Exterior Light Switch

Bulletin Type:	SRP	Publication Date:	September 2024
Bulletin #(s):	24-017	Make(s):	Jayco, Entegra Coach
Job Code(s):	<i>If affected unit has a warranty remaining, submit your claim following the normal process.</i>	Model(s):	Swift (20A, 20D, 20T) Swift LI (20AL, 20DL, 20TL) Solstice (21B) Comet (18C) Ethos (20A, 20D, 20T) Ethos LI (20AL, 20DL, 20TL) Expanse (21B) Arc (18C)
Flat Rate(s):		Model Year(s):	2021-2024

Incident:	Exterior light switch fails with weathering.
Affected Units:	2021-2024 Jayco Swift, Swift LI, Solstice, Comet; 2021-2024 Entegra Coach Ethos Ethos LI, Expanse, Arc
Parts List:	1 - SWITCH,PUSH SGL BLK WTRPF 12V (Jayco Part #2067654)
Misc. Tools & Supplies:	Screw Gun with Square Head Bit Wagos Sealant
Parts Return Information:	N/A

EXTERIOR LIGHT SWITCH REPAIR INSTRUCTIONS

Fig. 2

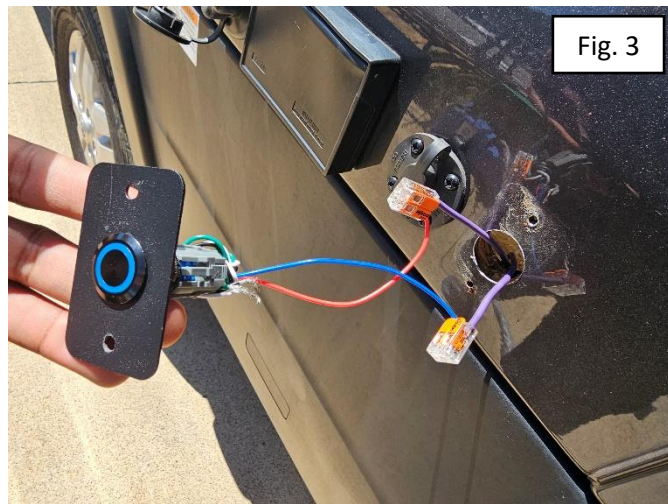
1. Remove the fasteners for the existing switch from the exterior of the coach. (Figure 1)
2. Disconnect the purple wires from the rear of the existing switch. (Figure 1)
3. With the switch free from the coach, remove it from the existing mounting plate.
4. Install the new switch onto the mounting plate. (Figure 2)
5. Connect the pigtail for the new switch to the rear of the switch. (Figure 2)
6. Cut off the female insulated terminals from the purple wires coming from the coach, and strip enough of the wire to be used in a Wago.
7. Using 2 way wagos, connect the red and blue wires from the switch pigtail to the purple wires from the coach. (Figure 3)
